**Re: Advanced Auto Parts
2807 San Mateo NE
Request Permanent C.O. - Accepted
Engineer's Stamp dated: 8-7-15 (H17D111)
Certification dated: 2-12-16**

CONSTRUCTION DRAWINGS
ADVANCE AUTO PARTS
SAN MATEO BOULEVARD AND CLAREMONT AVENUE
DRAINAGE AND GRADING PLAN

C5.0
SHEET 7 OF 13

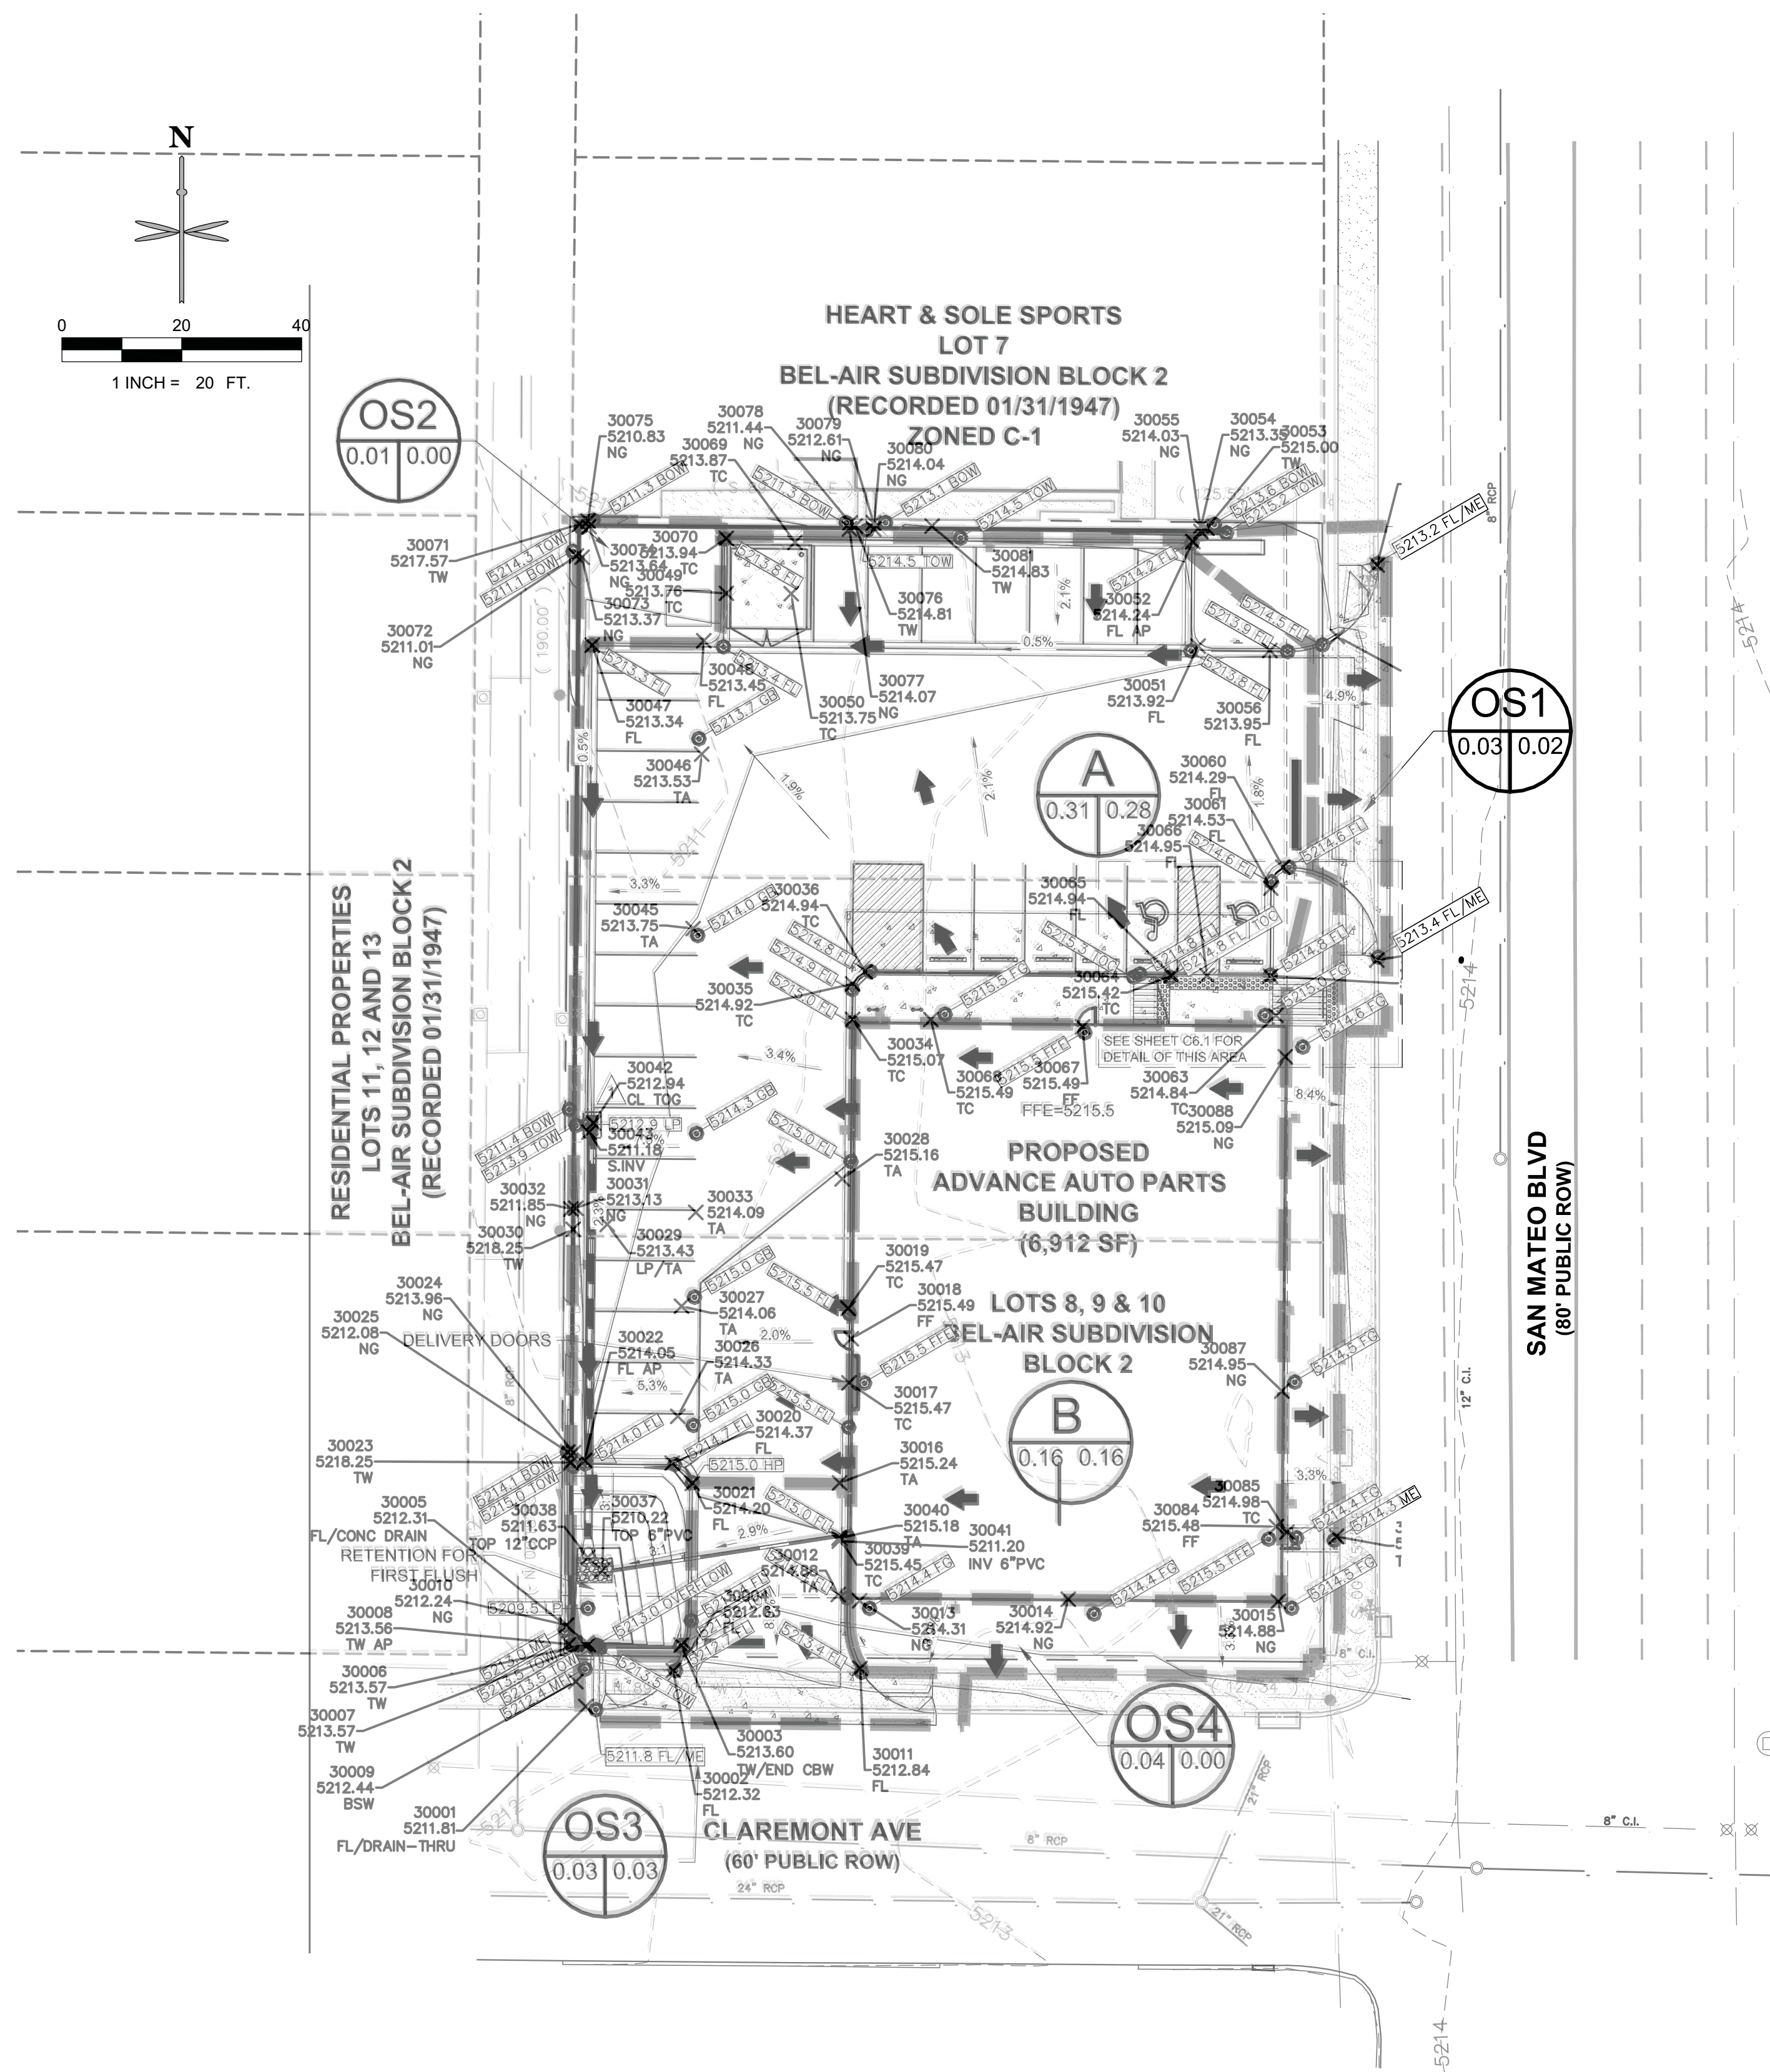
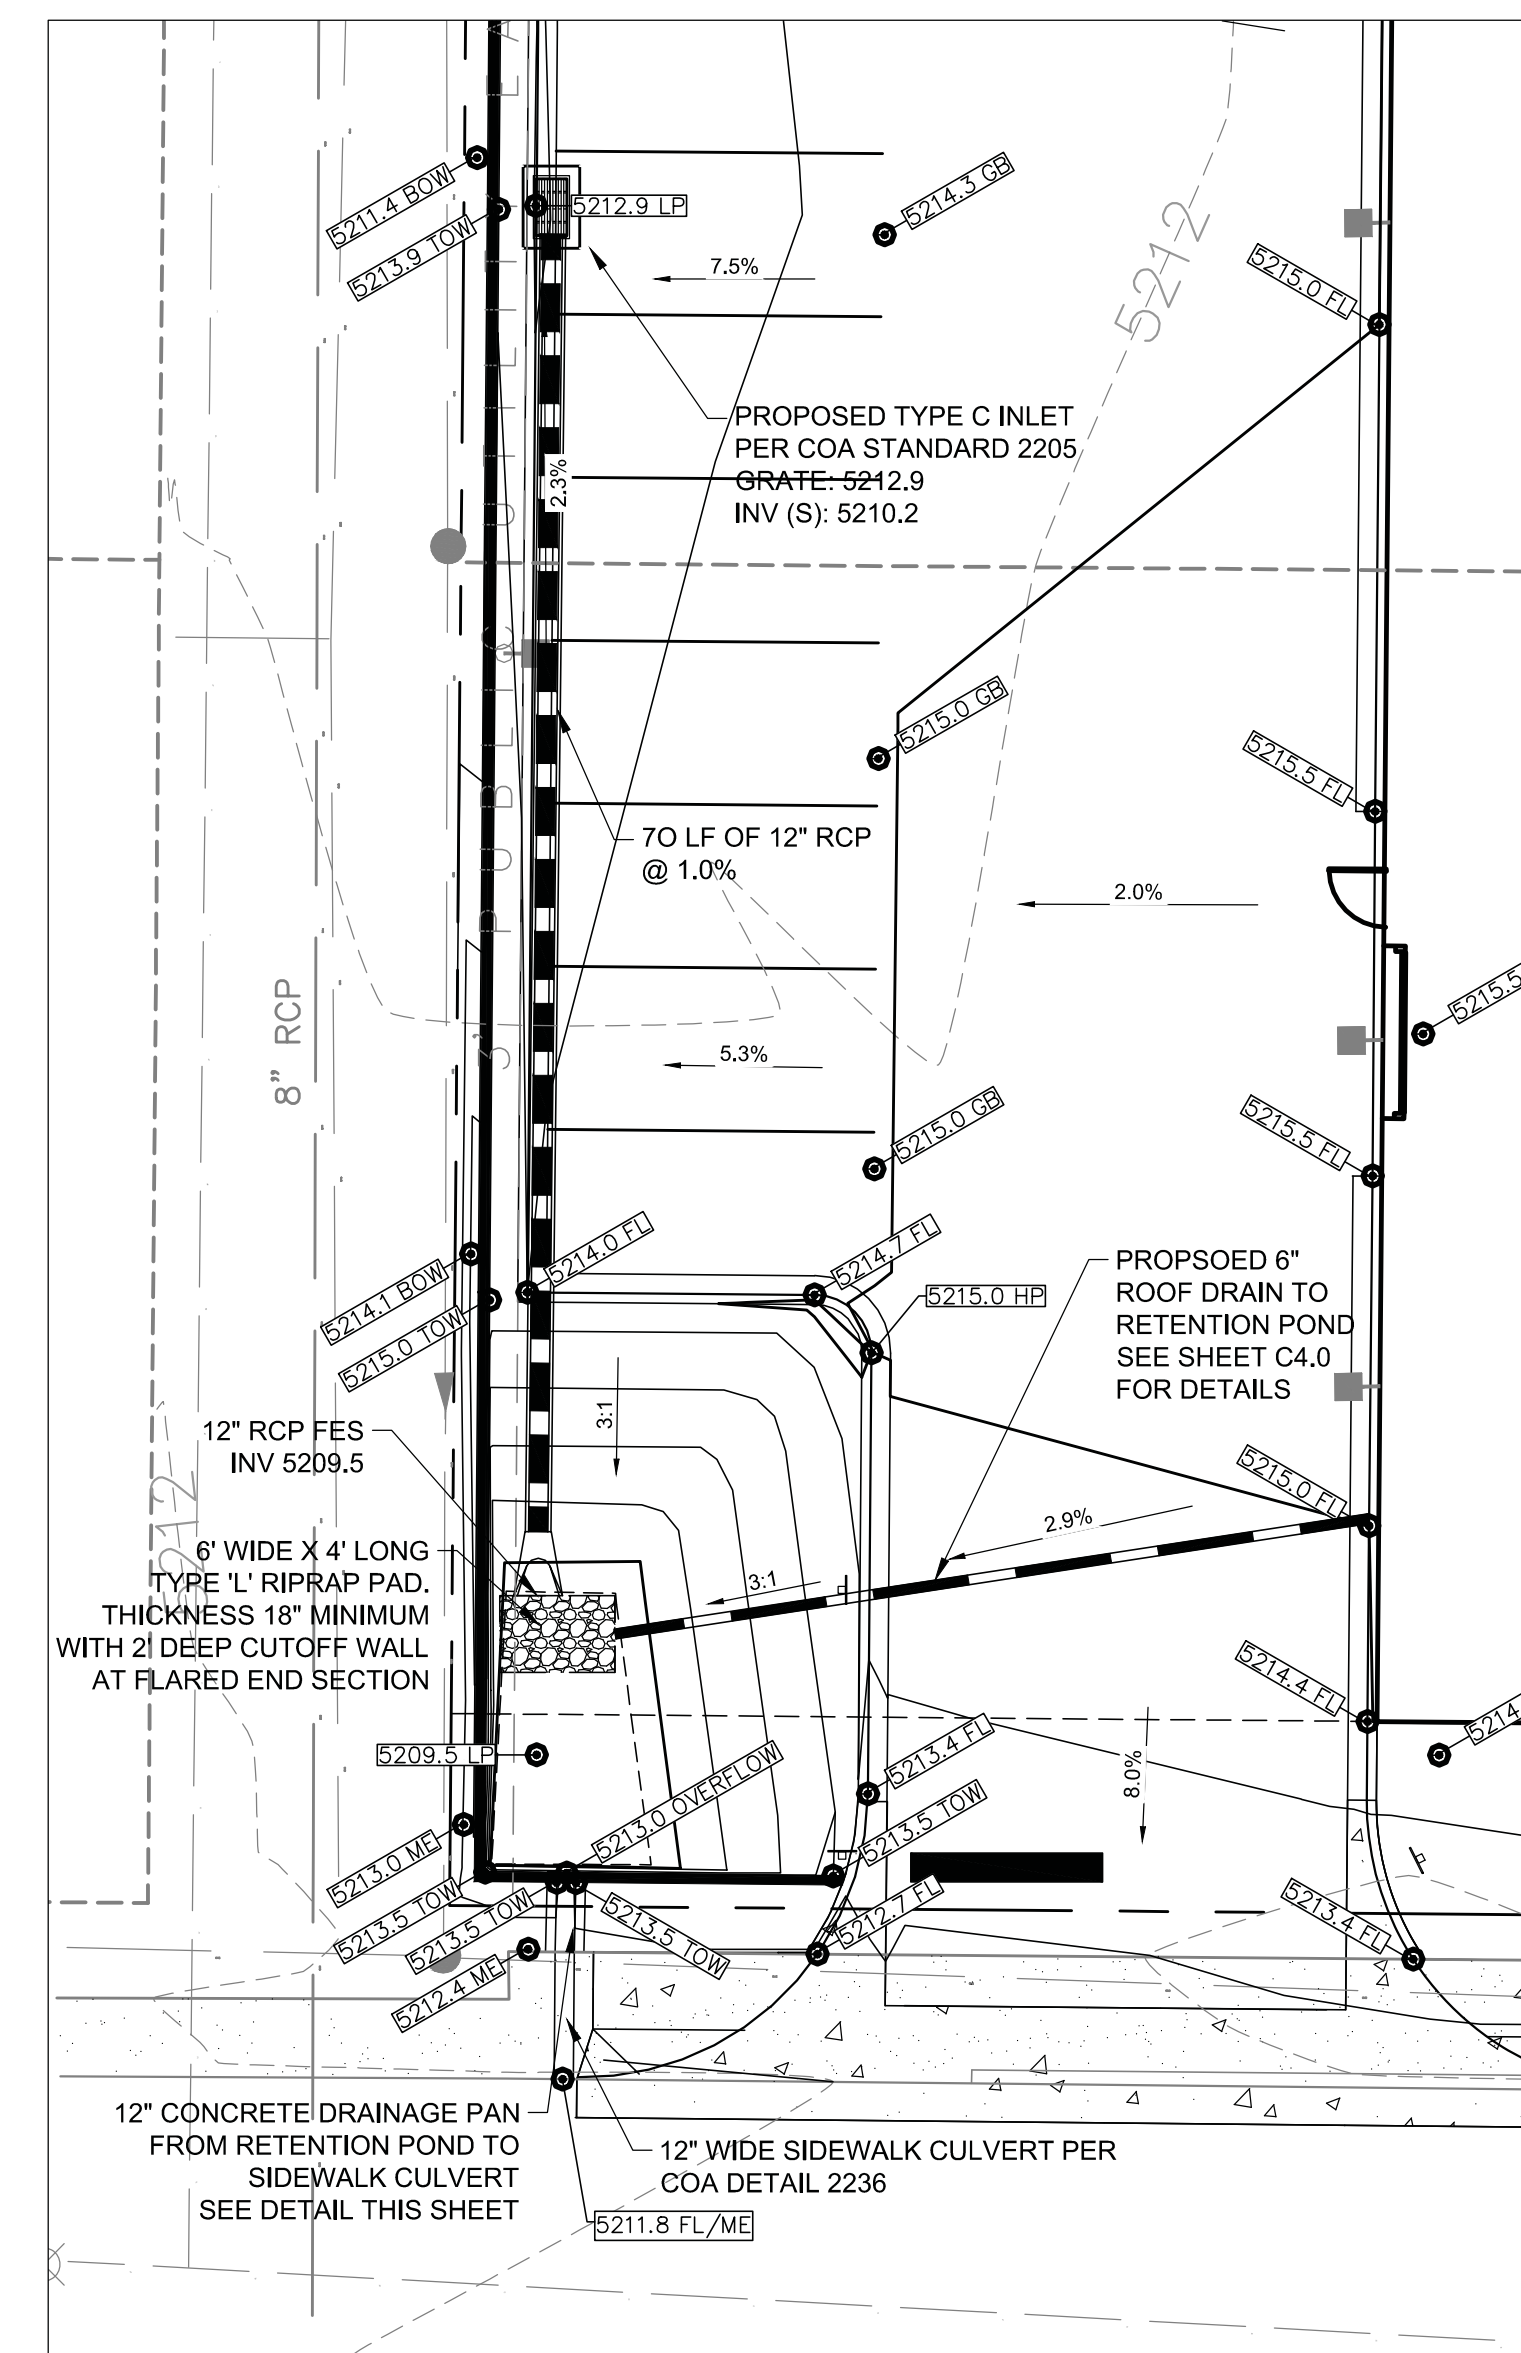
I David Soule, NMPE 14522, of the firm **Rio Grande Engineering**, hereby certify that this project has been graded and will drain in substantial compliance with and in accordance with the design intend of the approved plan dated 8/7/15. The record information edited on the original design document has performed by me or under my direct supervision and is true and correct to the best of my knowledge and belief. The as-built survey was provided Thomas Johnson 14269. The certification is submitted in support of a request for **PERMANENT CERTIFICATE OF**. The record information presented heron is not necessarily complete and intended only to verify substantial compliance of the grading and drainage aspects of this project. Those relying on this record document are advised to obtain independent verification of its accuracy before using it for any other purpose. southwest driveway exceeds ada built slope less than plan
